HARTZELL PROPELLER INC.
SERVICE LETTER
HC-SL-61-361
Propeller - Unfeathering Tool TE316

D. Description

**Unfeathering Tool TE316 Modification
Figure 1**

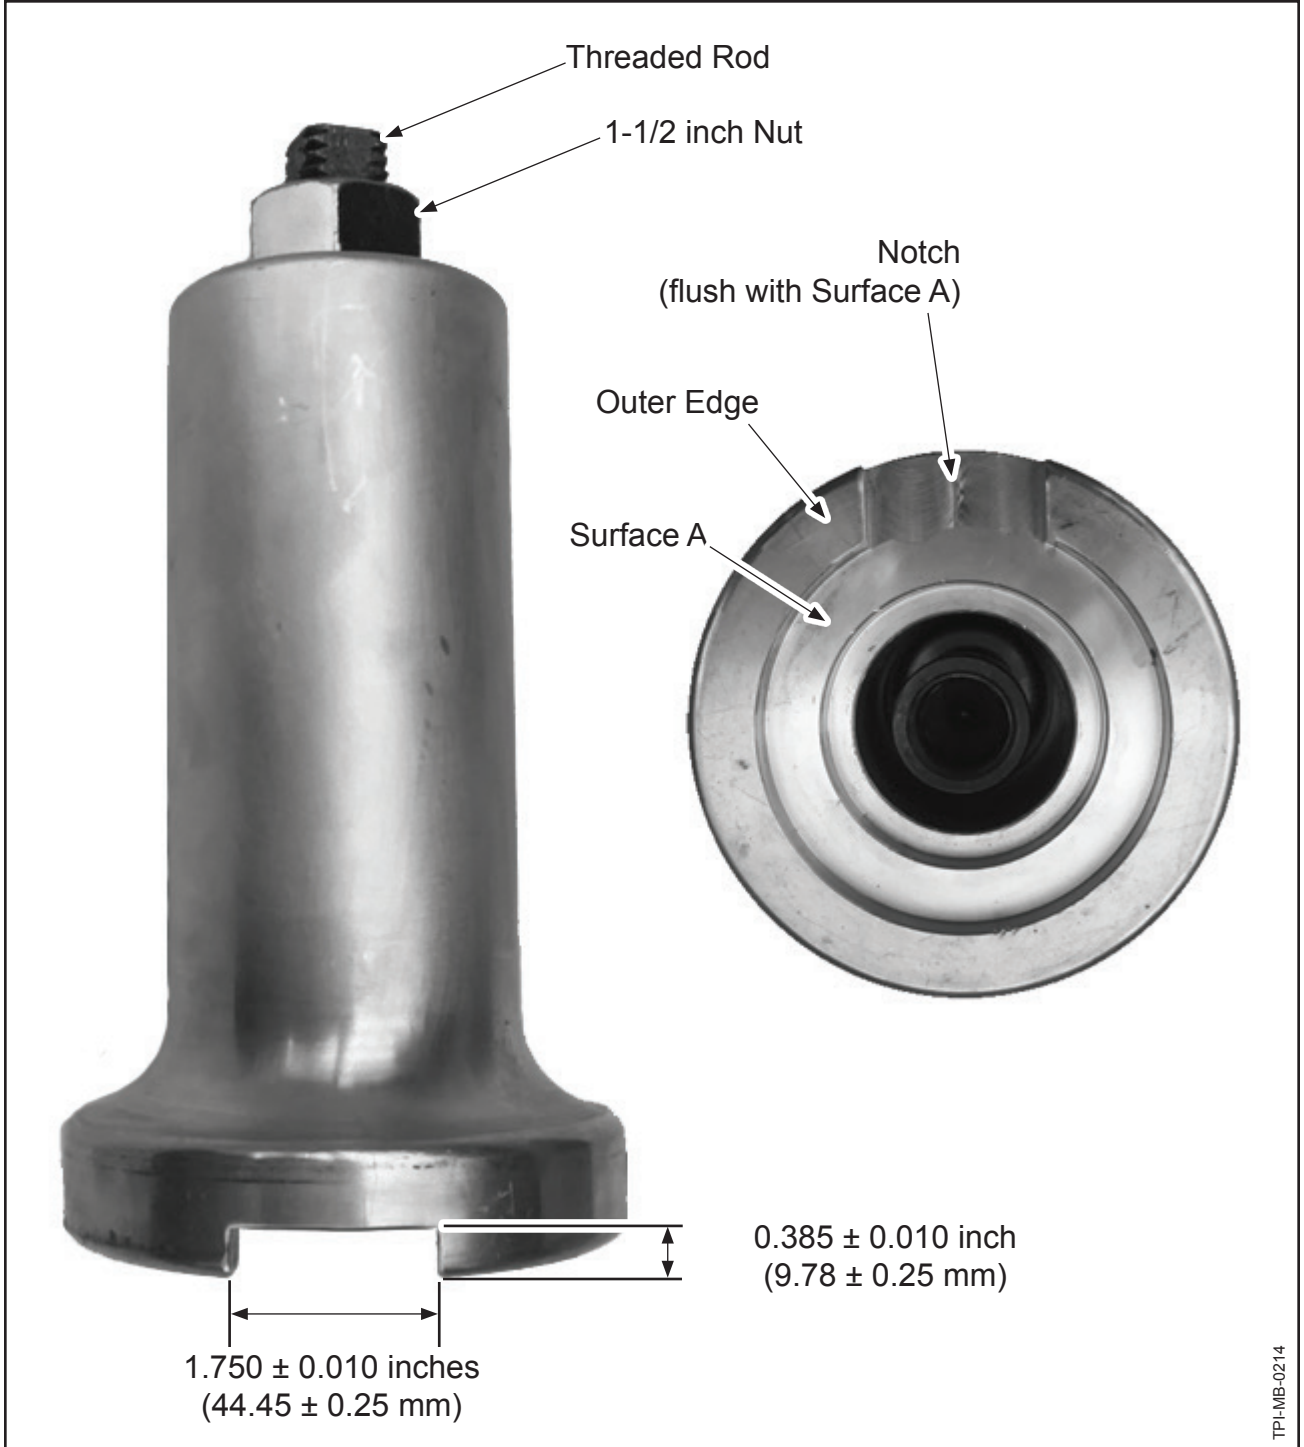
- (1) Machine a notch in the outer edge on the bottom of the unfeathering tool TE316 in accordance with the dimensions specified in Figure 1.
 - (a) The notch in the outer edge should be flush with Surface A.
 - (b) Machined edges must have a finished radius of 0.060 ± 0.030 inch (1.52 ± 0.76 mm) as shown in Figure 2.
